Proposal Content Document

Brockman Syncline Proposal
Assessment Number 2219

Hammersley Iron Pty Limited

Table 1-1: Consolidated Updated General Description of the Brockman Proposal

Figure 1-1
Development Envelope and
Indicative Location of Key
Proposal Elements

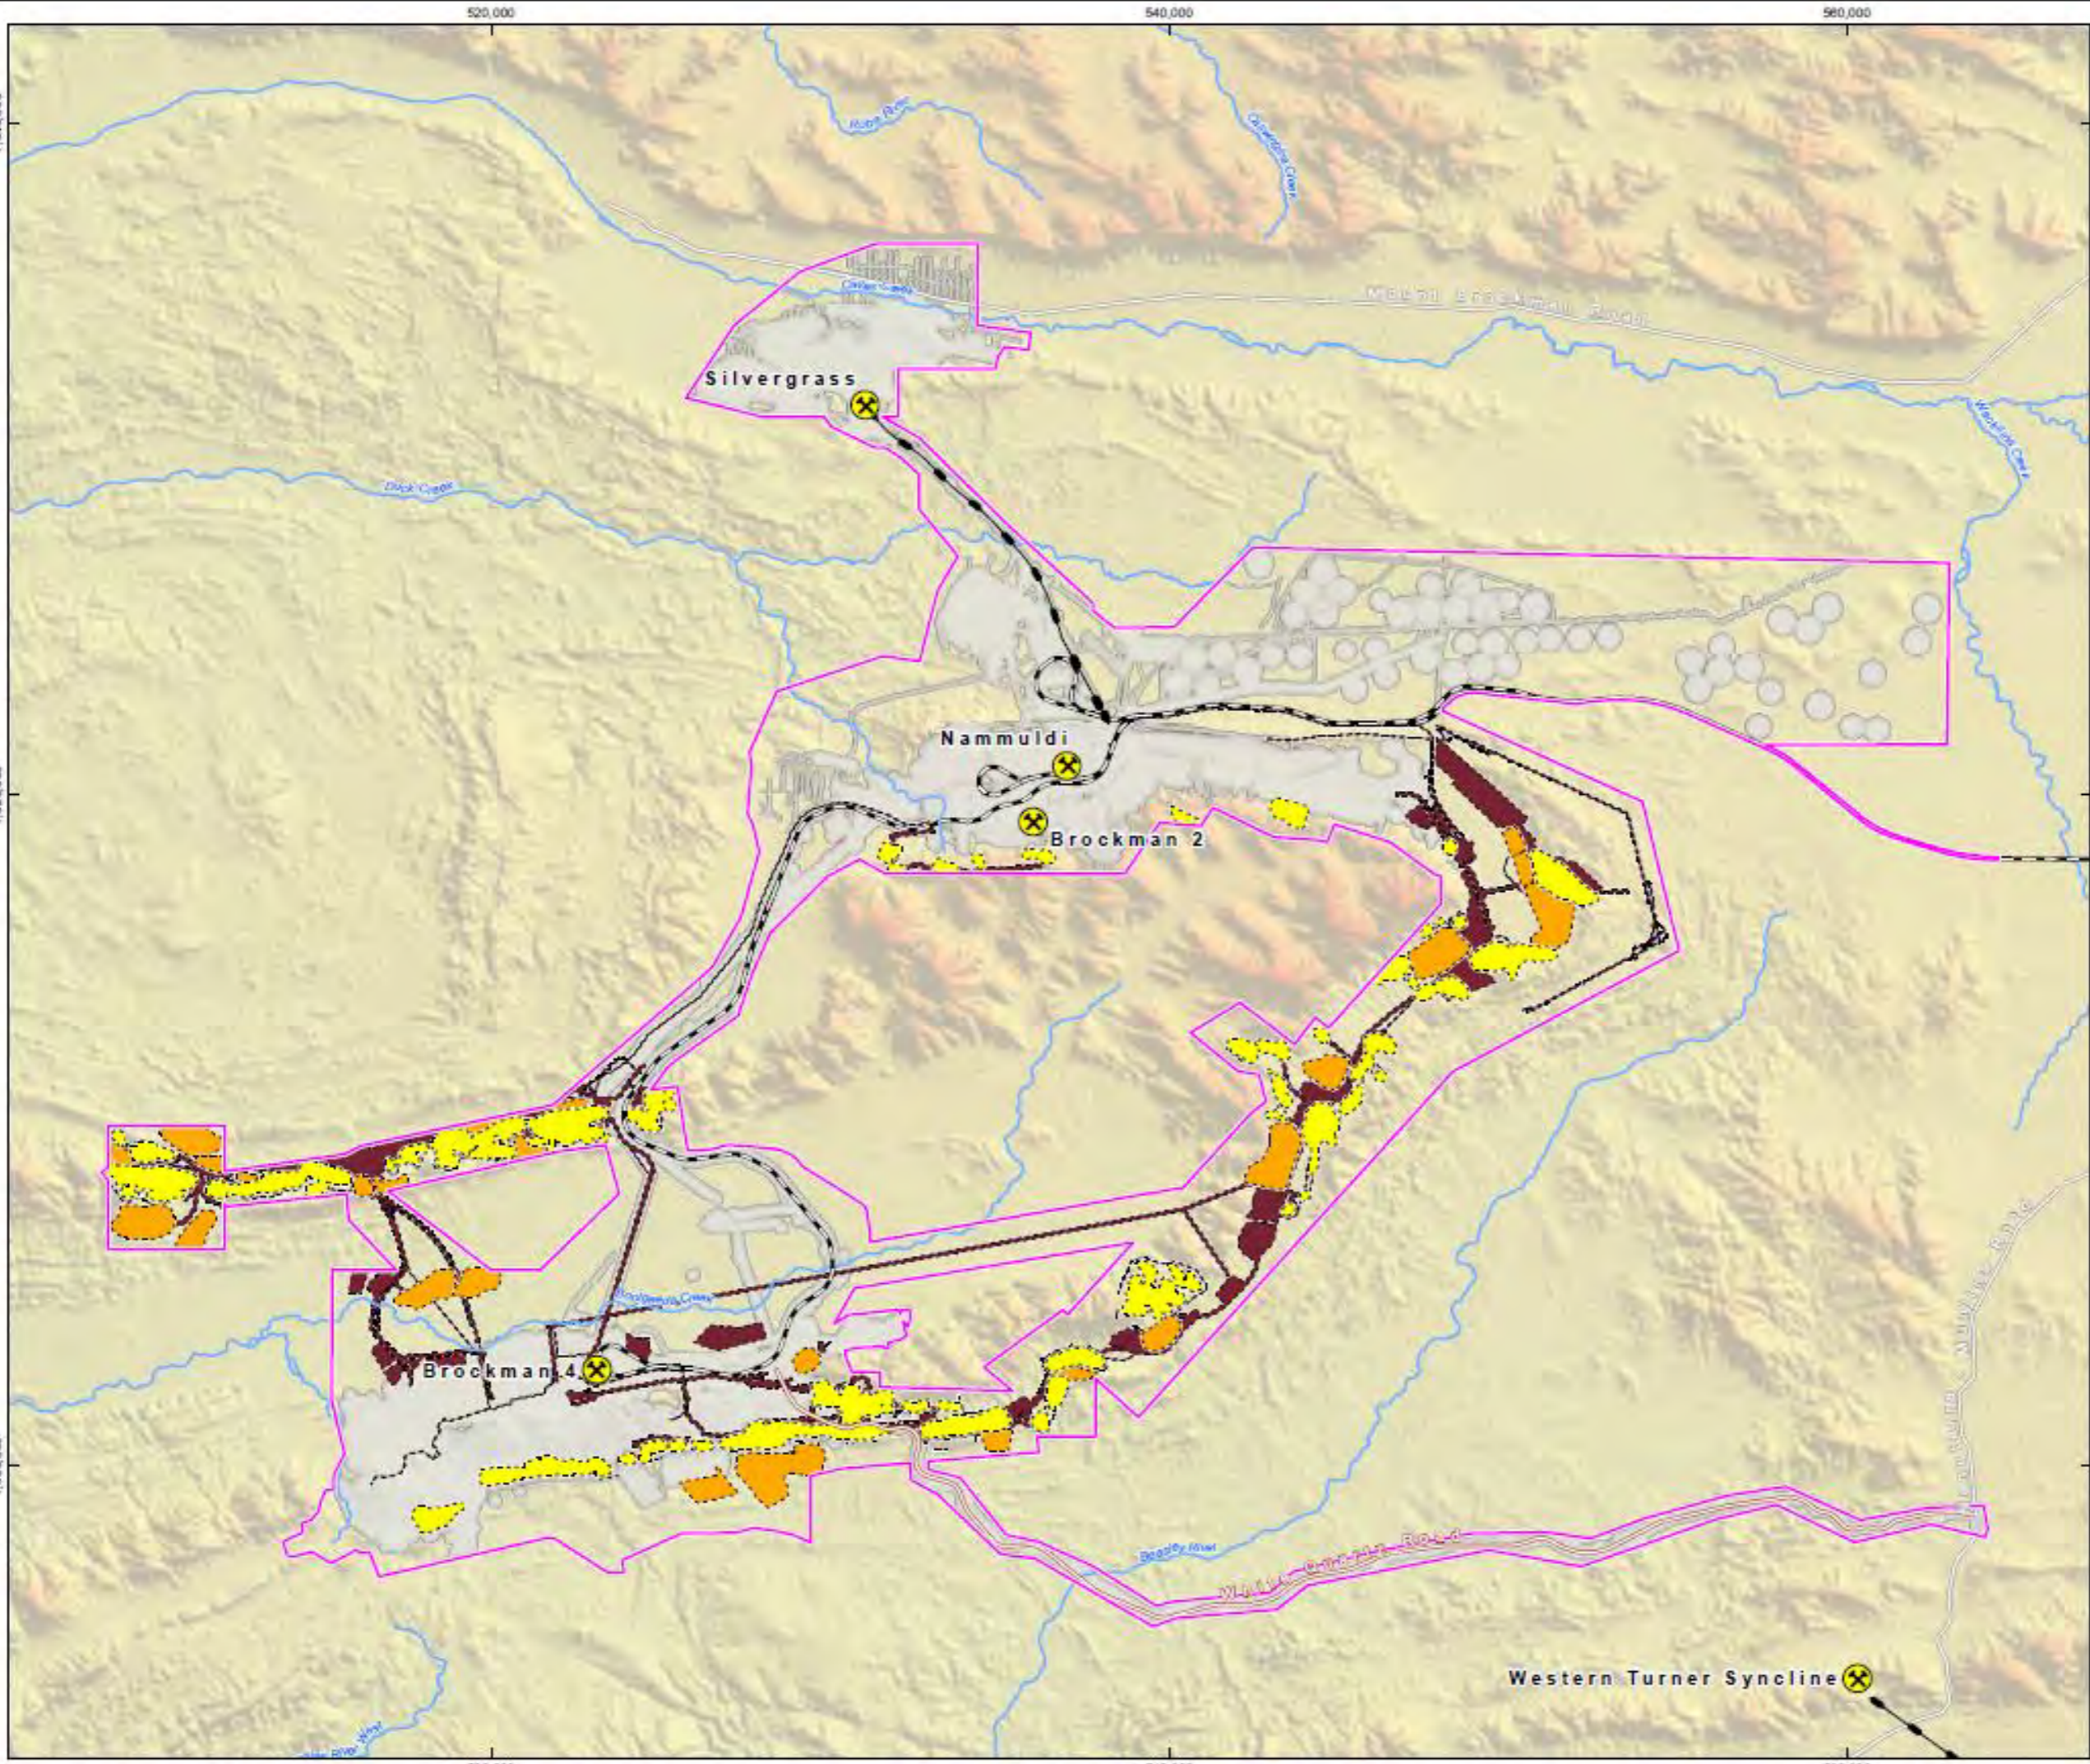
Element	Location	Approved Proposal Extent (MS 131, 867, 925 and 1000)	Proposal	Amended Proposal
Physical Elements				
Mine and associated infrastructure	Figure 1-1	<ul style="list-style-type: none"> MS 131 and 867: No clearing limit specified (estimated at 1,106 ha) MS 925: Clearing of up to 6,300 ha of native vegetation within the Nammuldi-Silvergrass Development Envelope MS 1000: Clearing of no more than 4,503 ha within the Brockman 4 Development Envelope 	Additional clearing of 7,896 ha within a 63,343 ha Development Envelope	Clearing of up to 19,805* ha within a 63,343 ha Development Envelope
Irrigated Infrastructure	Figure 1-1	Clearing of up to 2,500 ha within the Nammuldi Irrigated Area within the Development Envelope	No change	Clearing of up to 2,500 ha within the Nammuldi Irrigated Area within the 63,343 ha Development Envelope
Operational Elements				
Groundwater abstraction for water supply and mine dewatering	N/A	<ul style="list-style-type: none"> MS 925: Groundwater abstraction of 51 GL/a at Nammuldi and 68 GL/a at Silvergrass. Undefined for MS 131, 867 and 1000. 	Abstraction of up to 50 GL/a	Abstraction of up to 50 GL/a

**Figure 1-2
Modelled Wetting Front under
Natural No Flow Conditions for
Duck and Boolgeda Creek**

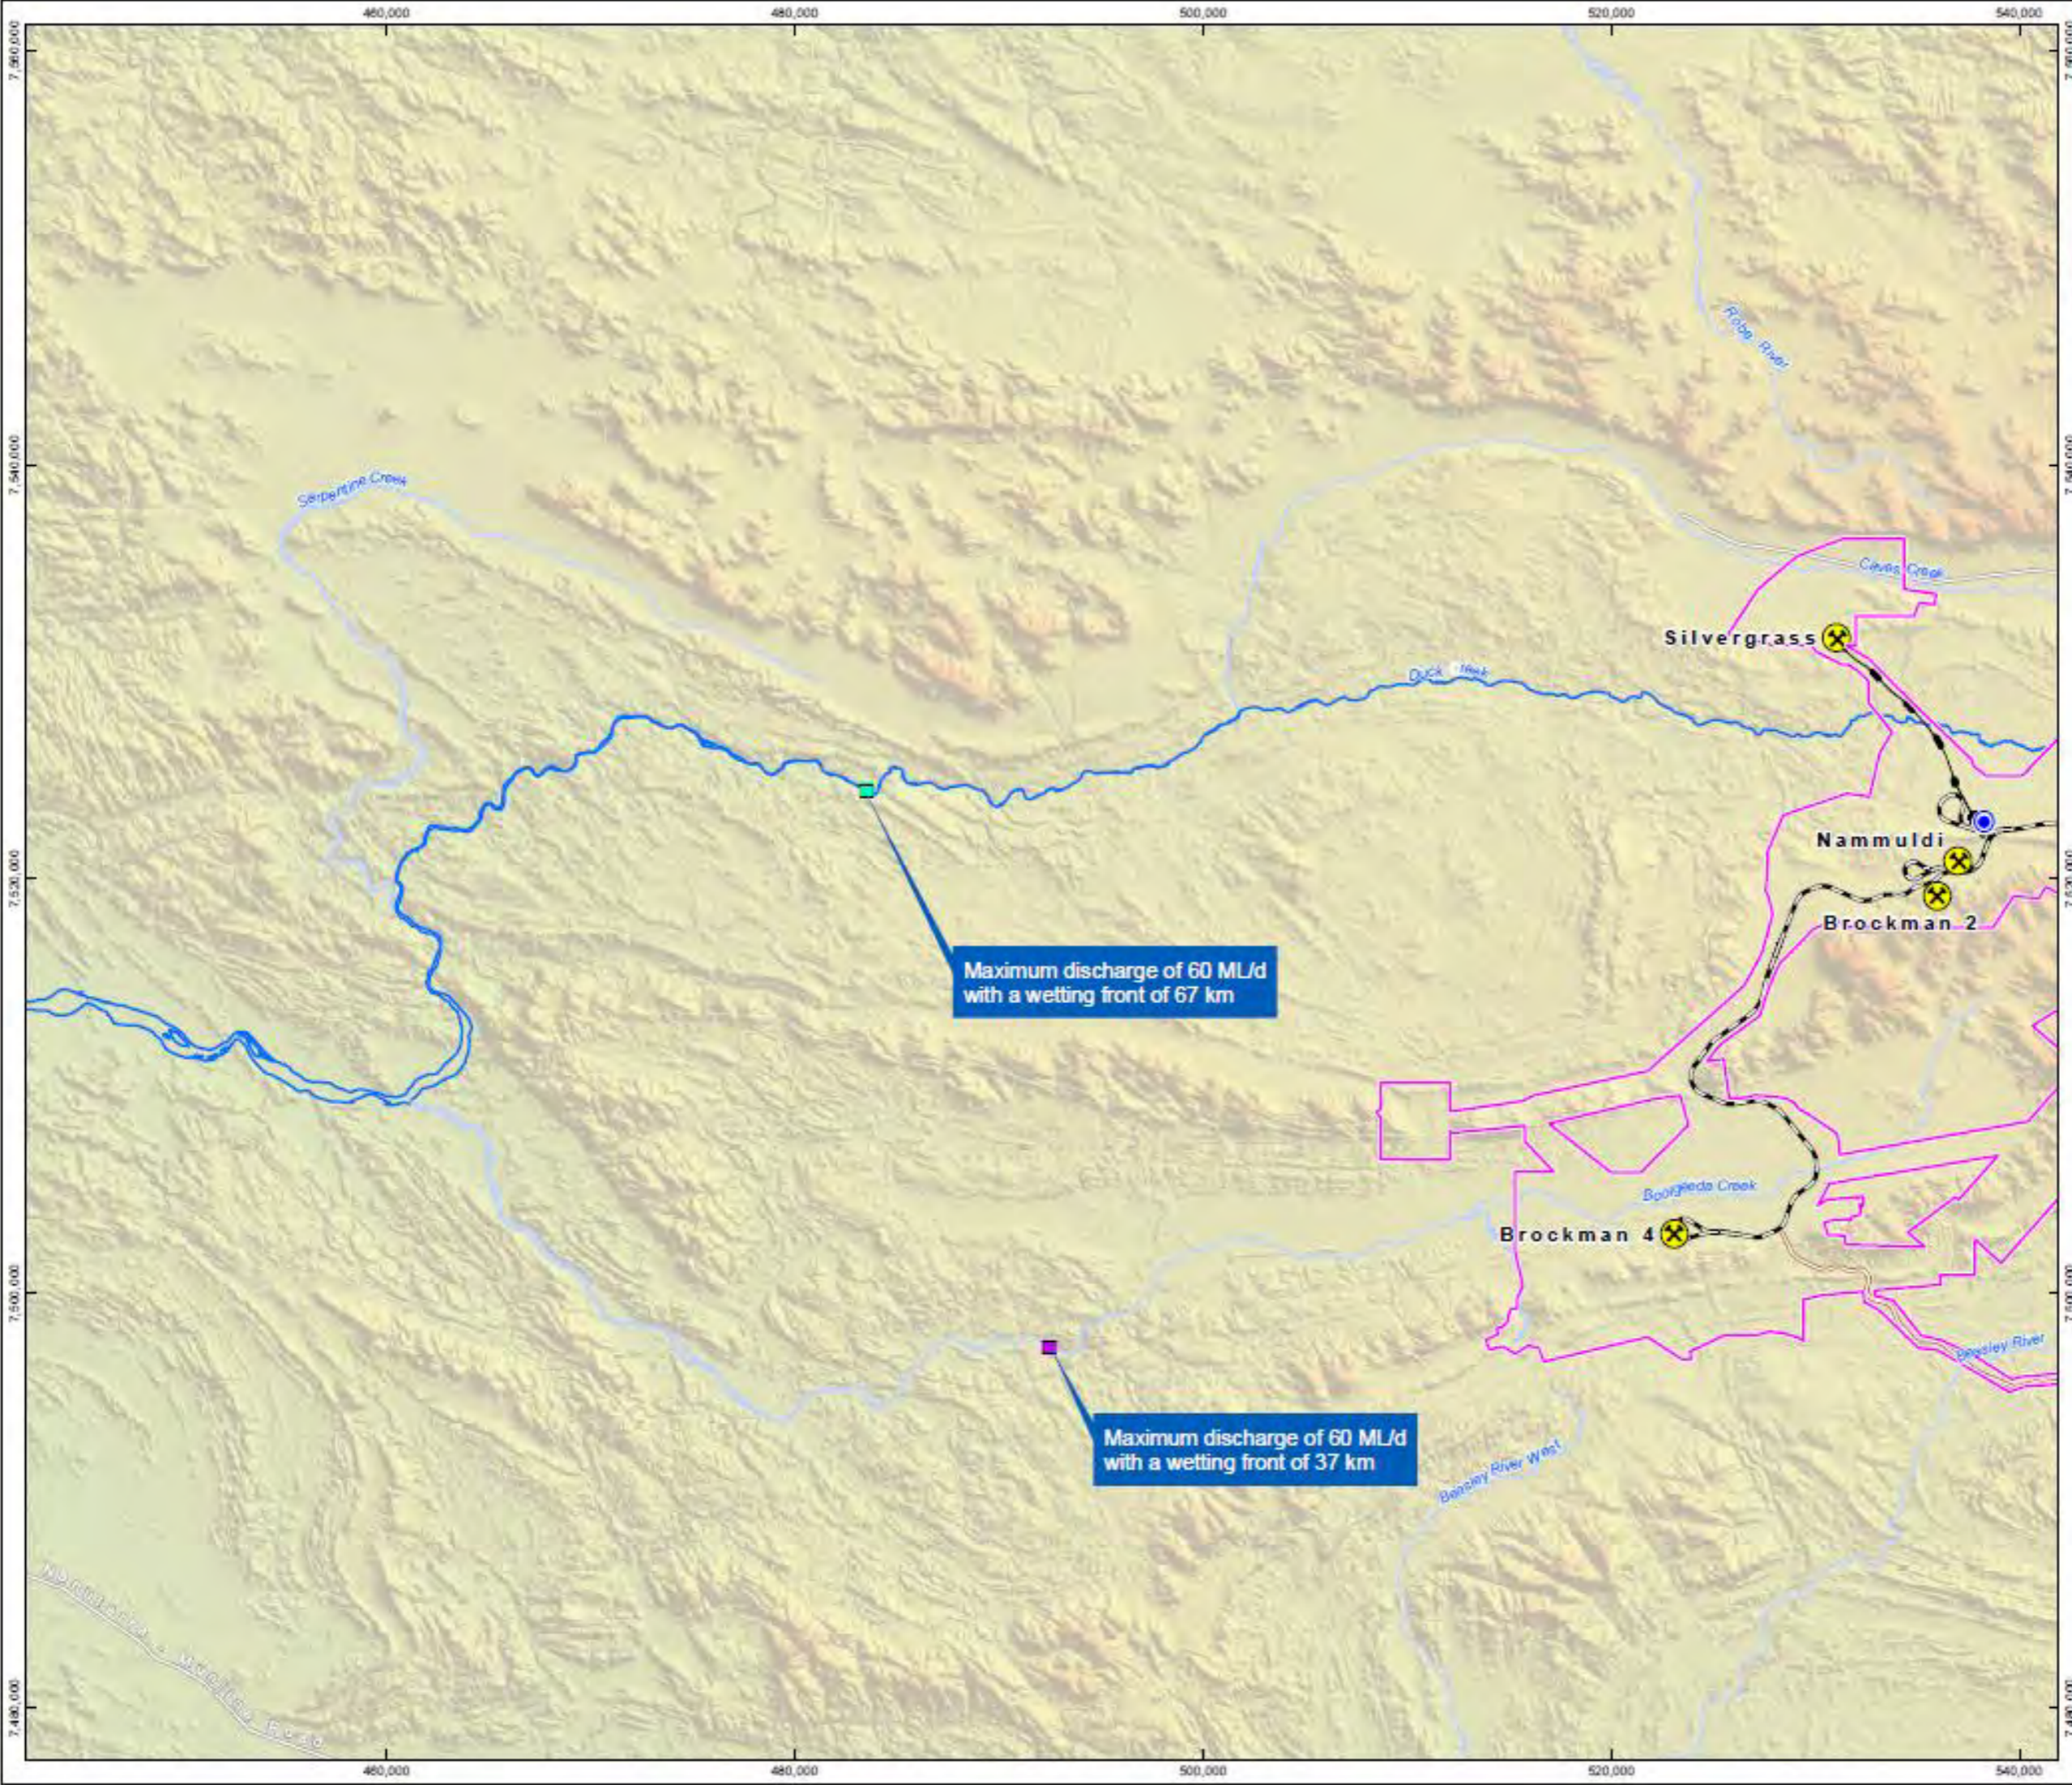
Management of Surplus Water	Figure 1-2	<ul style="list-style-type: none"> MS 131 and MS 867: Discharge of excess water to Pit 5 at 950 ML/a. MS 925: Transfer for offsite use; transfer to the Irrigated Agriculture Area and periodic 	Surplus water management options include: <ul style="list-style-type: none"> Use on site Discharge to disused pits Irrigated agriculture at Nammuldi 	Surplus water management options include: <ul style="list-style-type: none"> Use on site Discharge to disused pits Irrigated agriculture at Nammuldi

Element	Location	Approved Proposal Extent (MS 131, 867, 925 and 1000)	Proposal	Amended Proposal
		discharge to Duck Creek. <ul style="list-style-type: none"> MS 1000: Dewatering disposal through controlled discharge to surface drainage of Boolgeeda Creek. Dewater discharge to extend no further than 37 km along Boolgeeda Creek from the discharge point under natural no-flow conditions 	<ul style="list-style-type: none"> Provision to other users Controlled discharge to the environment via Duck and Boolgeeda Creek with a wetting front not exceeding 67 and 37 km respectively, under natural no-flow conditions. 	<ul style="list-style-type: none"> Provision to other users Controlled discharge to the environment via Duck and Boolgeeda Creek with a wetting front not exceeding 67 and 37 km respectively, under natural no-flow conditions.
Backfill of Pits	Figure 1-1	<ul style="list-style-type: none"> Partial backfill of Pits 1, 4, 4 extension, 5 and 6 at BS2¹ Backfill of BS2 pit to sufficient depth to ensure that, following mine closure and backfilling, the groundwater water table will permanently remain at least 3 metres below the lowest point of the pit floor² All open cut Marra Mamba pits in the Silvergrass area to be backfilled to above the post-mining water table levels³ BS4 Mine Pits are to be backfilled so that the final surface levels are at a higher elevation than the pre-mining groundwater level to prevent the formation of pit lakes (Pits 2, 3, 4, 5, 6, 7, 10, 11, 12, 15, 16, 17 and 18)⁴ 	<ul style="list-style-type: none"> Backfill of BS3 Extension Deposits (MMJ and Creekside) 	<ul style="list-style-type: none"> Partial backfill of Pits 1, 4, 4 extension, 5 and 6 at BS2¹ Backfill of BS2 pit to sufficient depth to ensure that, following mine closure and backfilling, the groundwater water table will permanently remain at least 3 metres below the lowest point of the pit floor² All open cut Marra Mamba pits in the Silvergrass area to be backfilled to above the post-mining water table levels³ BS4 Mine Pits are to be backfilled so that the final surface levels are at a higher elevation than the pre-mining groundwater level to prevent the formation of pit lakes (Pits 2, 3, 4, 5, 6, 7, 10, 11, 12, 15, 16, 17 and 18)⁴ Backfill of BS3 Extension Deposits (MMJ and Creekside) to above post mining recovered water levels
